Amendments to the Drawings:

REMARKS/ARGUMENTS

In response to the Office Action of December 31, 2003, Applicant requests re-examination and reconsideration of this application for patent pursuant to 35 U.S.C. 132.

Figure 1
Prior art

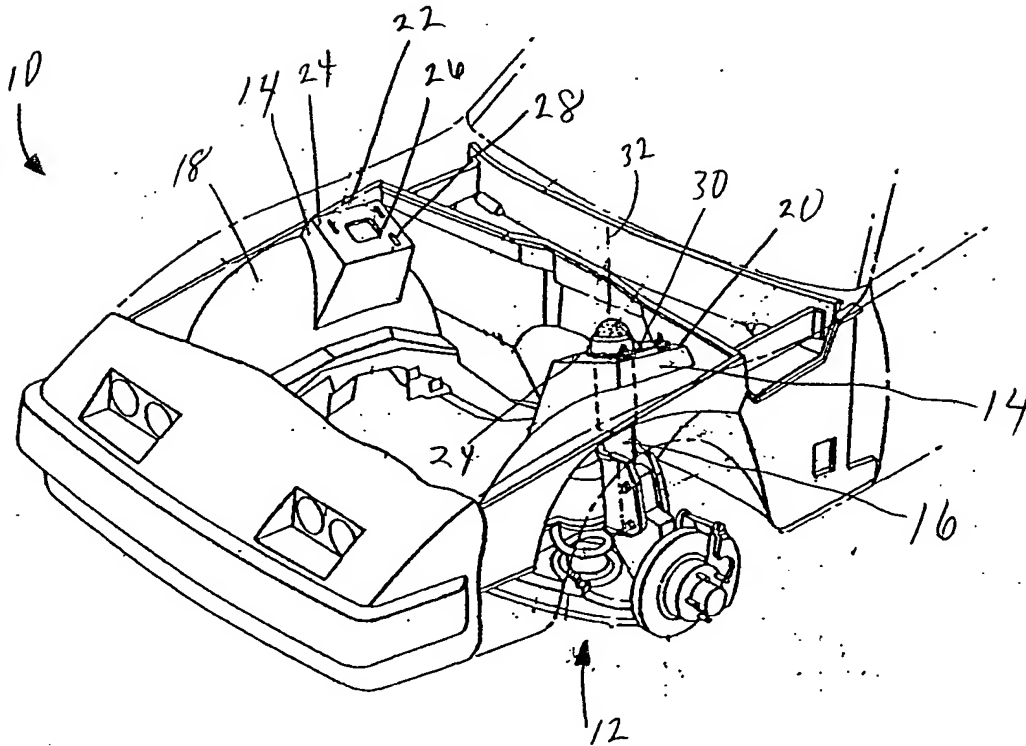
The attached sheets of drawings include changes to Fig. 1. This sheet replaces the original sheet. In Figure 1, previously omitted phrase "prior art" has been added.

In amended Figure 1, the previously omitted phrase "Prior Art" has been added.

Figure 2

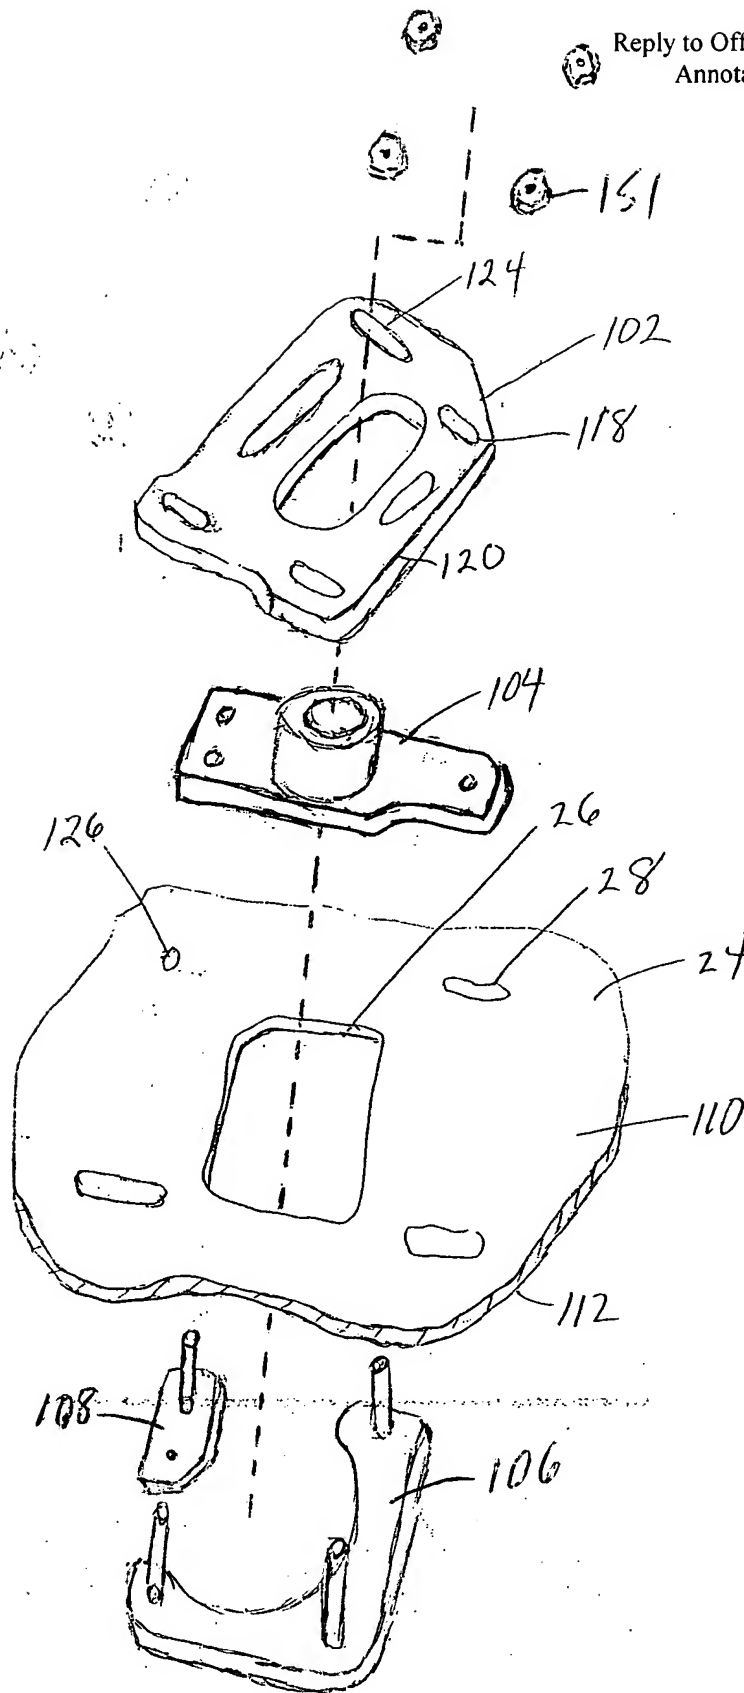
The attached sheets of drawings include changes to Fig. 2. This sheet replaces the original sheet. In this sheet a dashed line illustrating how the parts fit together has been added. This sheet also includes editorial changes to help with clarity regarding assembly of the device.

In amended Figure 2, a dashed line showing how the parts fit together has been added. In addition, Fig. 2 includes illustrative changes to clarify assembly of the device. Fig. 2 also now includes the threaded nuts.

Claims 1-17 stand rejected under 35 USC 112, first paragraph, as failing to comply with the enablement requirement. Figure 2 has been amended to more clearly illustrate the assembly of the invention. Specifically, plates 106 and 108 have been rotated to illustrate that the bolt or stud of plate 108 aligns with aperture 126 while the bolts or studs of plate 106 align with the elongated slots 28 of the mounting plate.

Figure 3

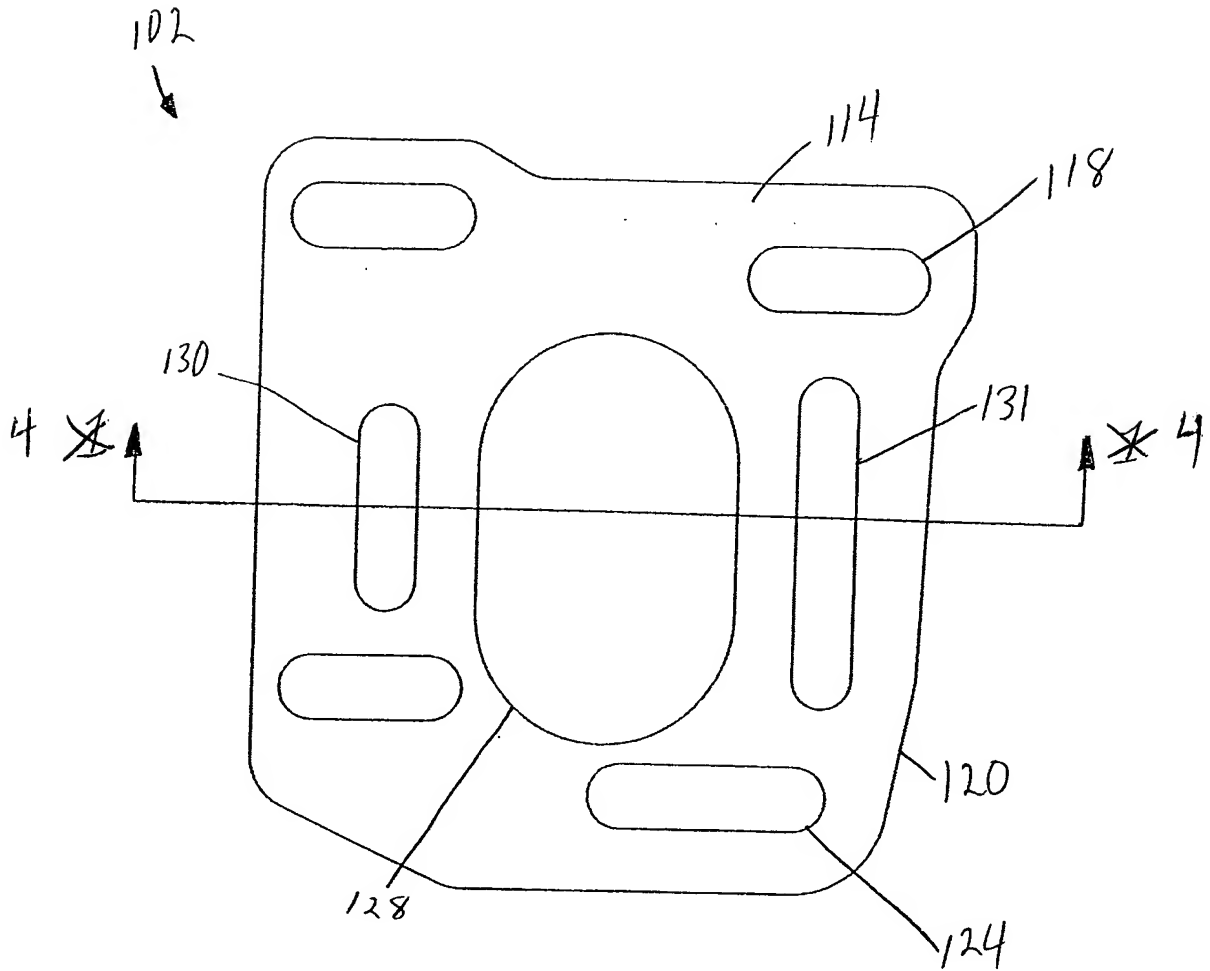
The attached sheets of drawings include changes to Fig. 3. This sheet, which includes Figs. 3 and 4, replaces the original sheet including Fig. 4. In Figure 3, line 1-1 has been amended to line 4-4.

In amended Figure 3, line 1-1 has been amended to line 4-4.

Applicant is uncertain as to the statement regarding a circular aperture in the lower left corner of plate 102 as shown in Fig. 3. Fig. 3 contains all elongated apertures, as shown in Fig. 3. New Fig. 3 is provided herewith to provide clarity.

Figure 4

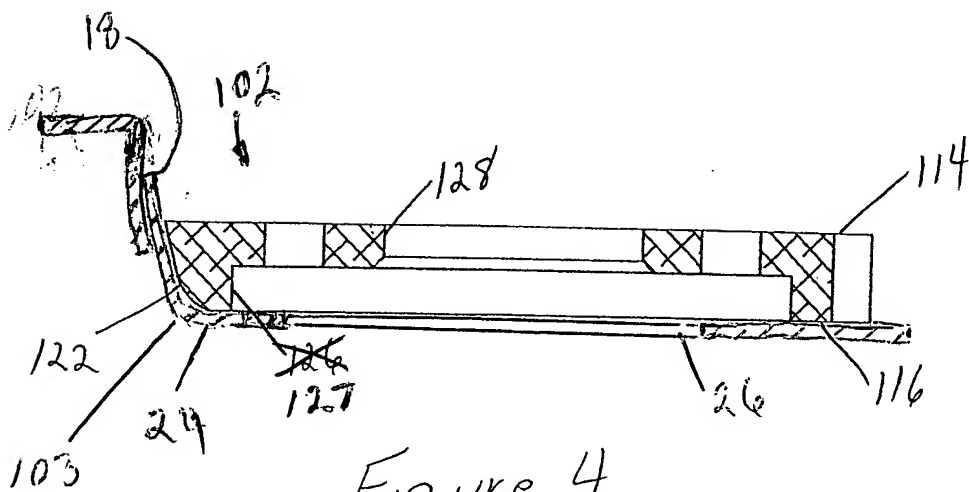
The attached sheets of drawings include changes to Fig. 4. This sheet, which includes Figs. 3 and 4, replaces the original sheet including Figs. 3 and 4. In Figure 4, reference number "126" has been amended "127". Fig. 4 also now includes portions of the inner fender wall 18 and mounting plate 24 to further illustrate the cooperation between the upper plate and the fender wall and fillet 103 as requested by the Examiner.

In the specification, page 20 line 3, the numerical designator 103 has been added. The designator refers to amended Fig. 4 which illustrated the fillet is a segment of a radius. Fillets are commonly formed during the bending of sheet metal components as it is difficult to form perfect right angles without fracturing or tearing the sheet metal. In addition, fillets are used to add strength the finished sheet metal assembly.
